**HISTORIC PRESERVATION BOARD MEETING
CITY OF ST. PETE BEACH
COMMISSION CHAMBERS**

Thursday, August 6, 2026
2:30 PM

DRAFT HISTORIC PRESERVATION BOARD MINUTES

SITE PLAN

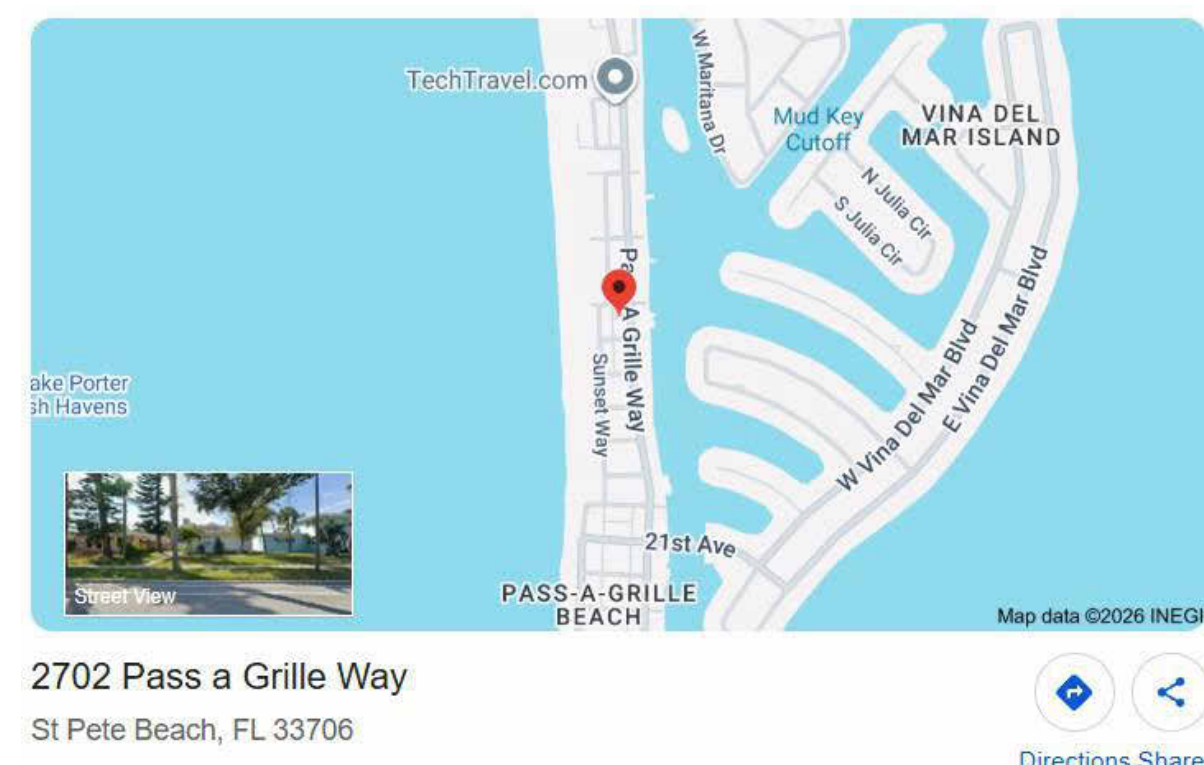
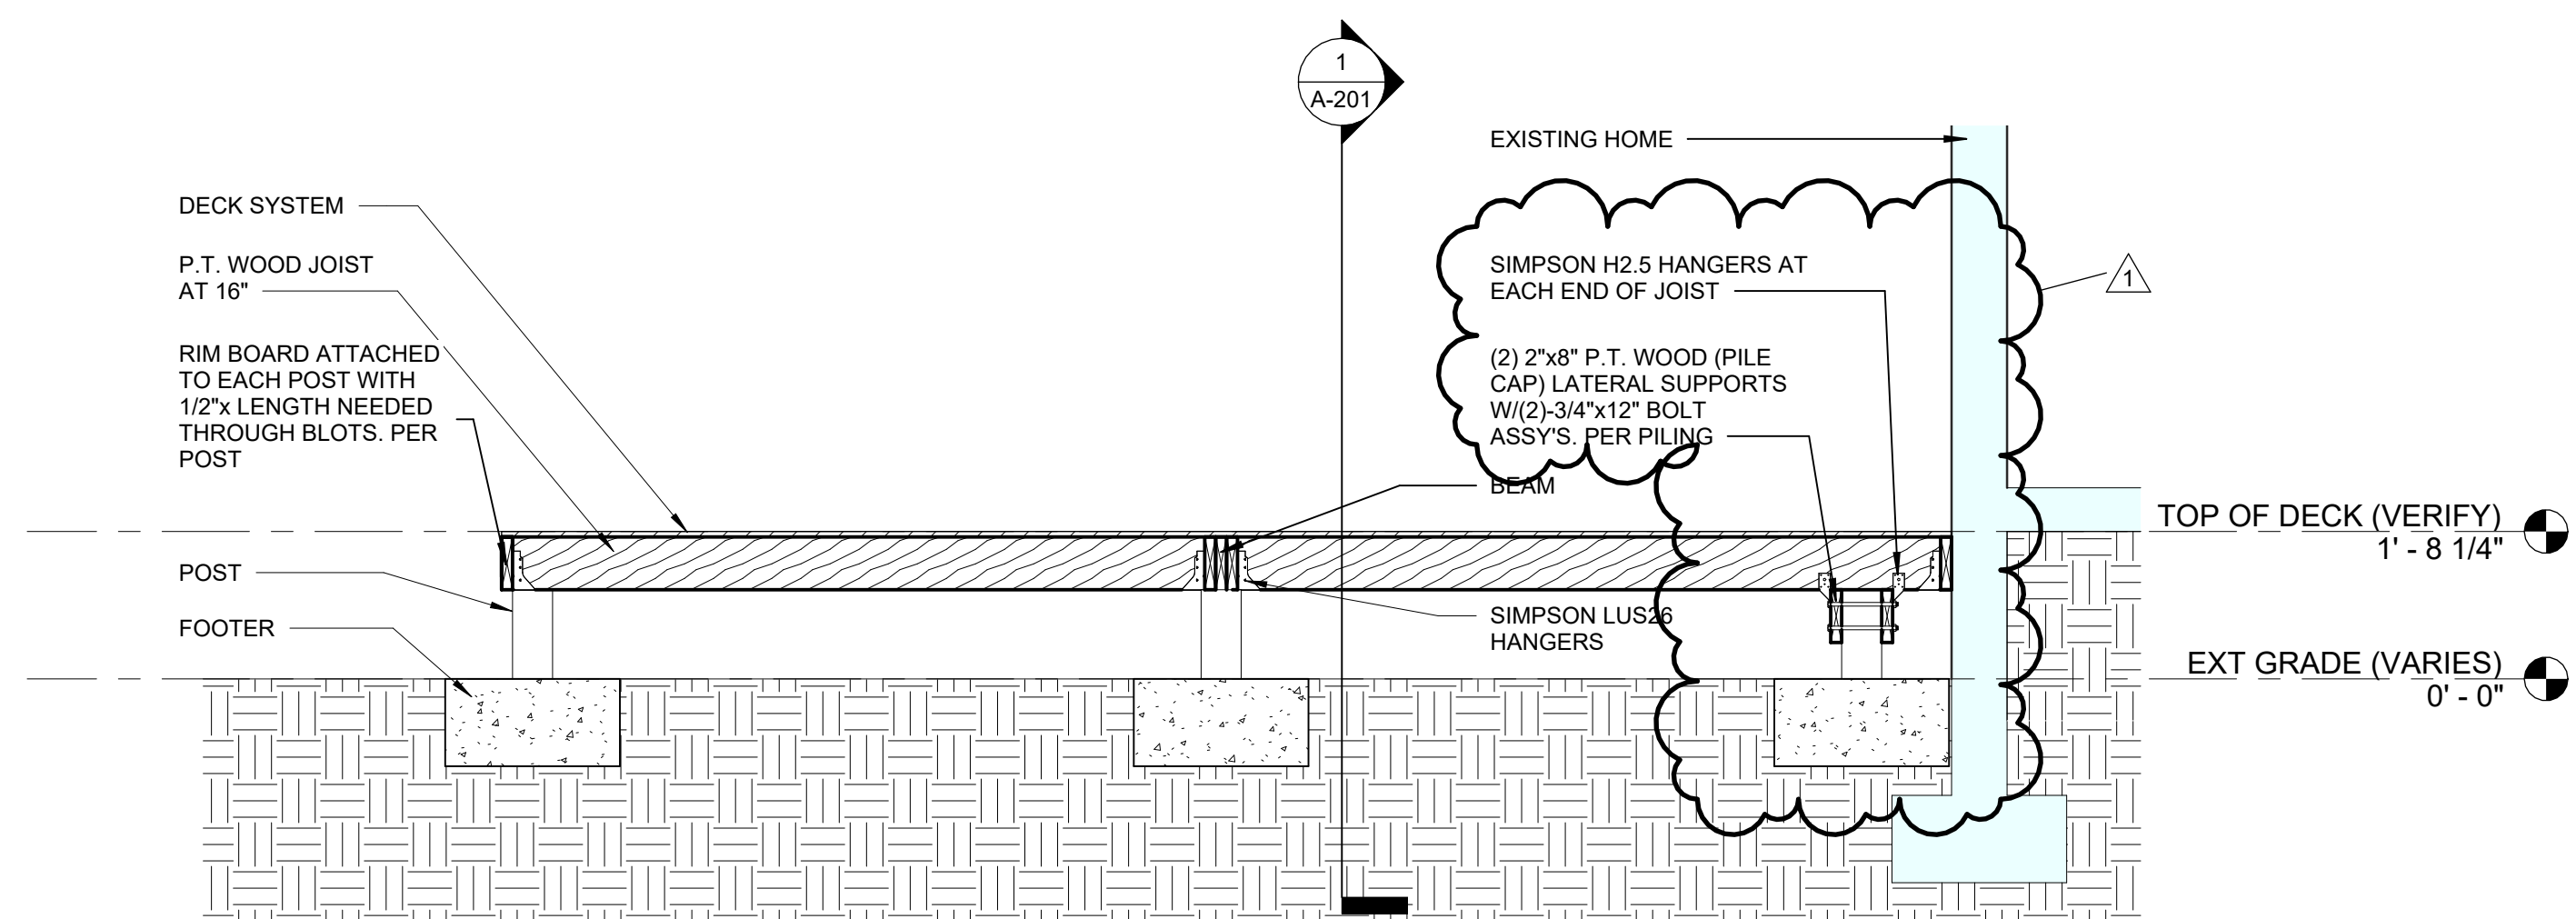
The owners of the property were approved at the June 2026 Board of Adjustment meeting to reconstruct their deck in its existing footprint, which is approximately one foot from the side property line where five feet is required. The deck the reconstruction will replace was originally constructed in the 1980s and is not itself a historic aspect of the residence. It extends approximately a foot and a half from grade in the southern side yard of the property, although there is slight variation beneath the surface of the approximately-400-square-foot deck. The deck will be independently supported from the residence via posts and footers. The major change will be the use of HDPE, a type of recycled plastic decking, in lieu of lumber, which is the current deck's material and which sustained significant damage from the 2024 hurricanes. In discussion with the owner, the replacement decking boards are intended for longevity.

Staff finds the request meets the certificate of appropriateness criteria. While the deck surface is synthetic, the most visible element of the railing will be aluminum, consistent with the late-1930s age and architecture of the residence. The addition replaces and is in a similar footprint to the existing deck, is low in stature and recessed to the rear side of the residence, and the addition does not remove any distinctive materials or affect the spatial relationships of the property. It does not alter any historic element of the property or affect the residence's features or finishes. The deck could be removed or replaced in the future without damaging the primary structure, although the distance between the adjacent door and the ground would require stairs with landing or a similar deck element as the one proposed. No chemical treatments are to be undertaken. Staff finds the addition meets the Secretary of the Interior's ten criteria listed in Land Development Code Sec. 28.8., and the four criteria for additions in Section 28.10.

1 PROPOSED GARAGE LEVEL FLOOR PLAN
SCALE: 1/4"=1'-0"

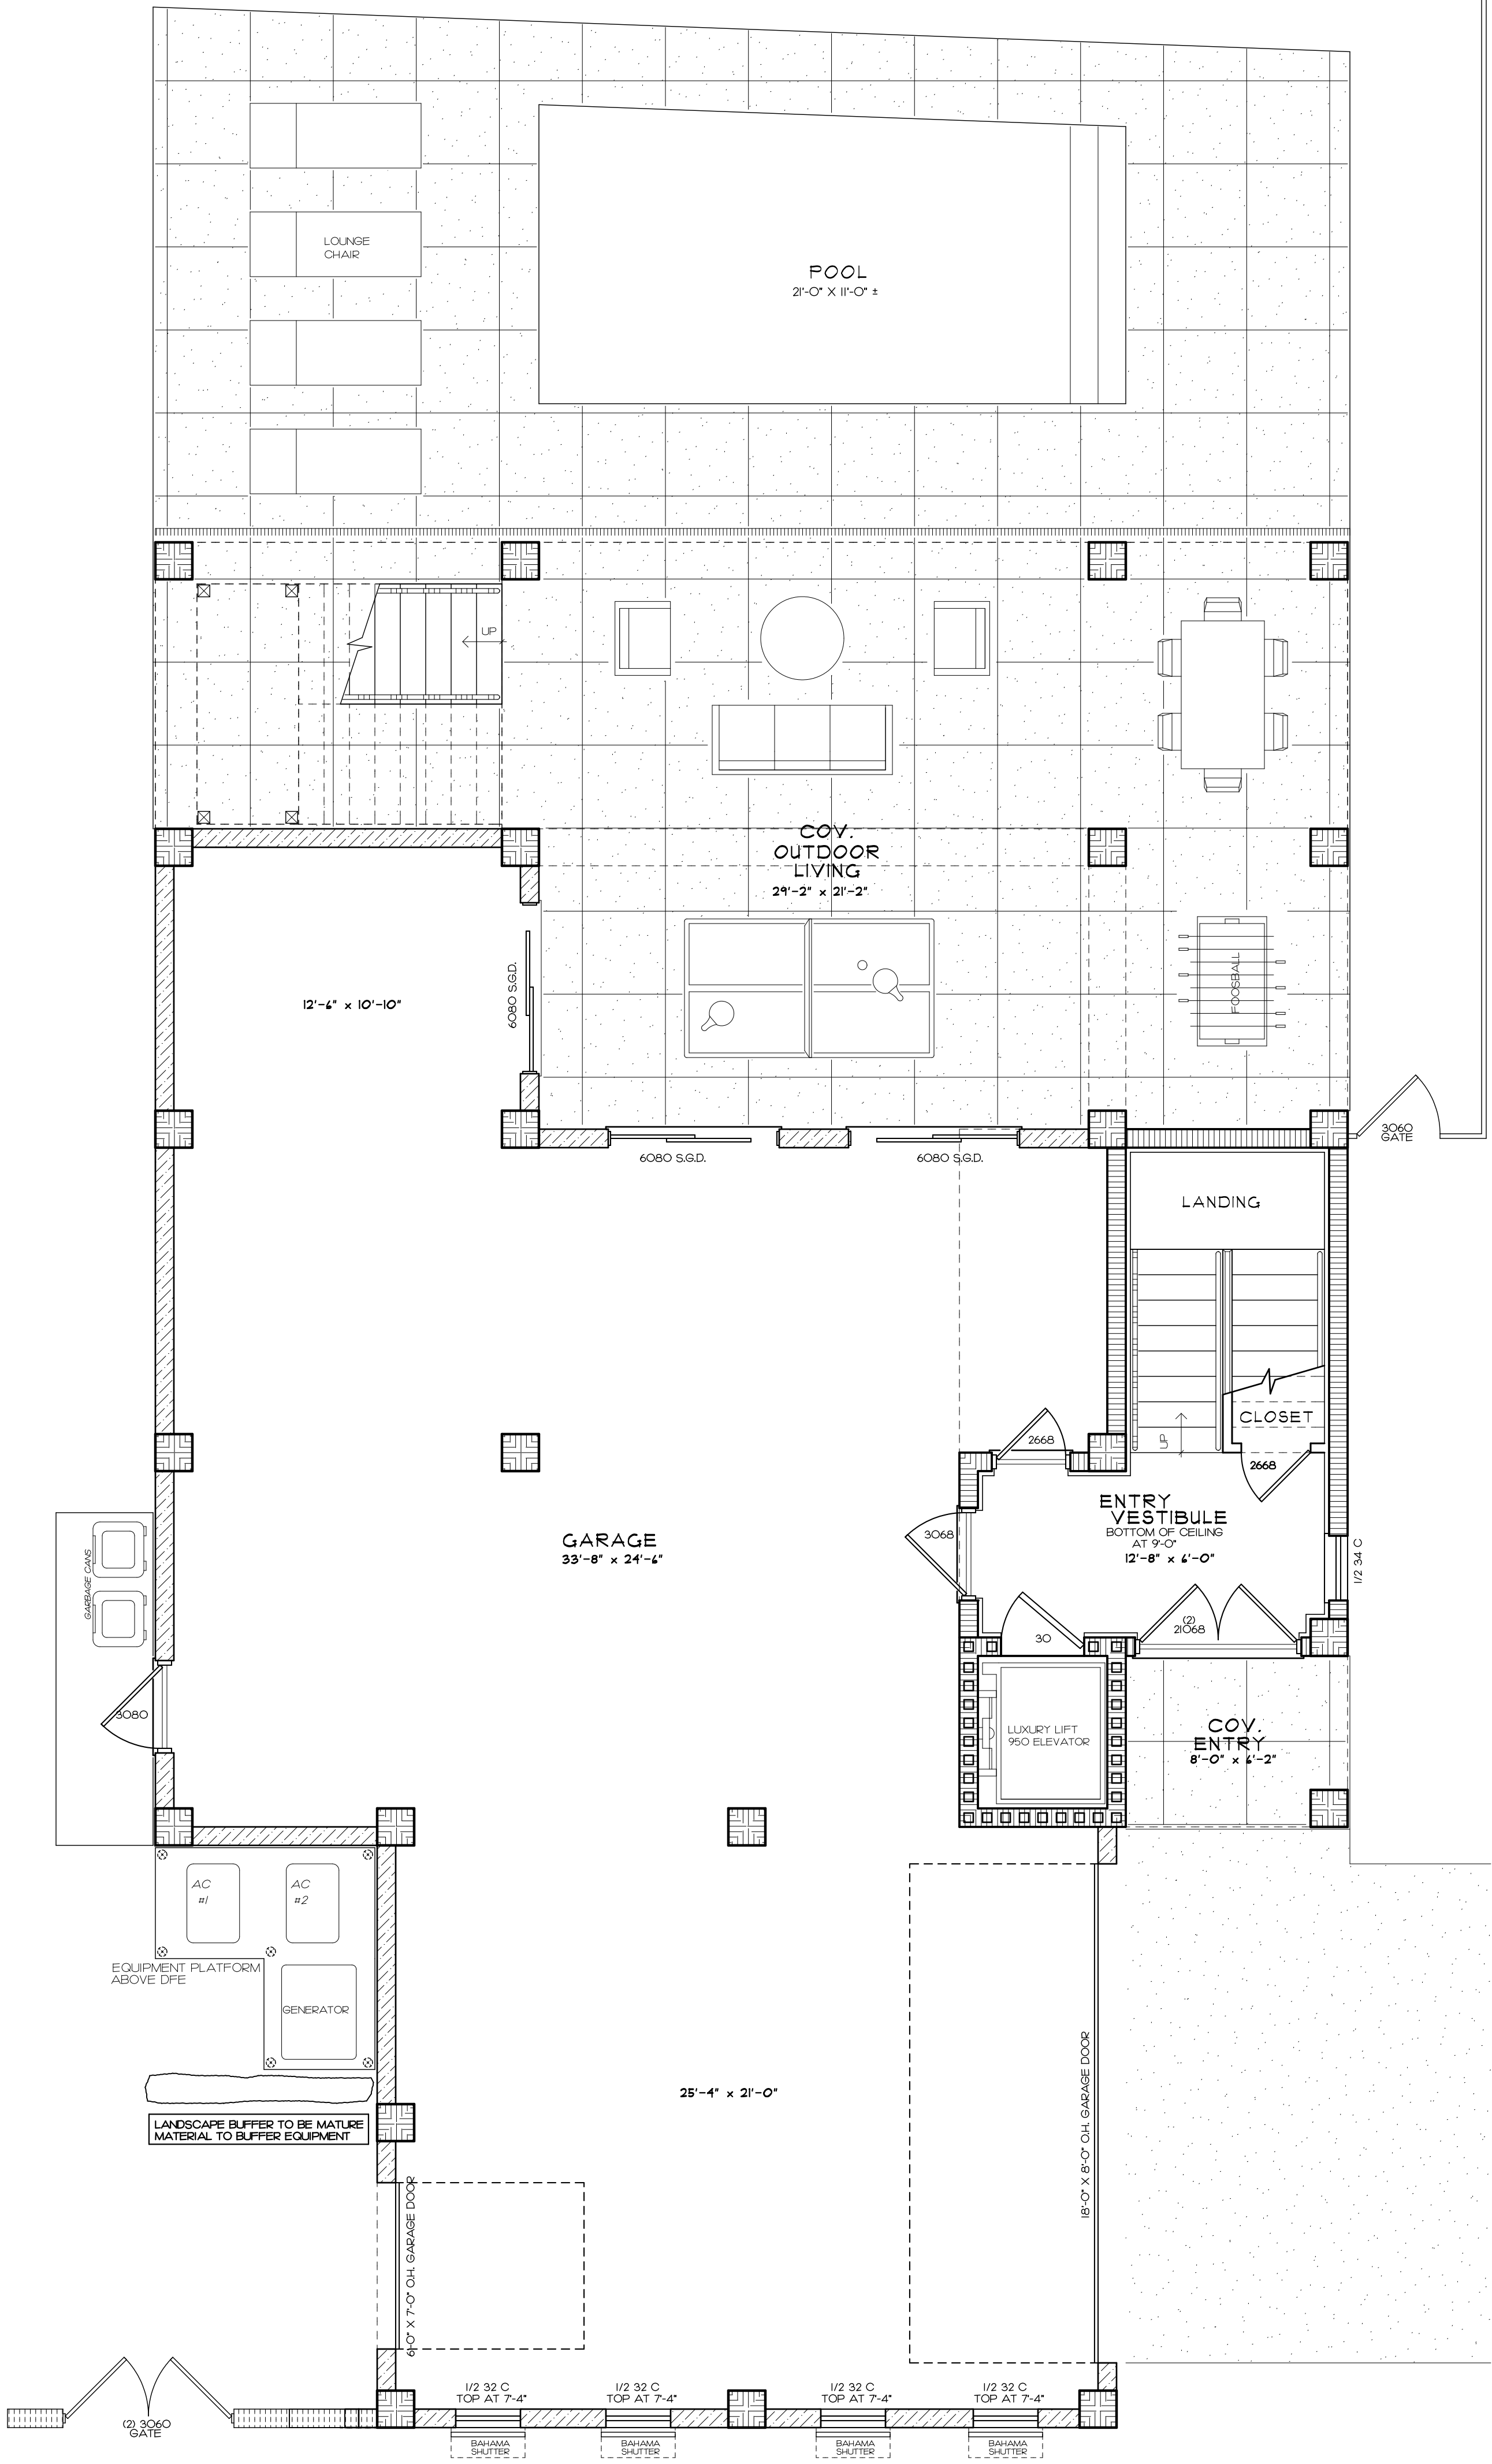
Staff's only zoning comment is that the lot is limited to two driveways not to exceed 20 feet in width at the property line, and the subject development appears to provide for three with the two separate accesses at the rear alleyway.
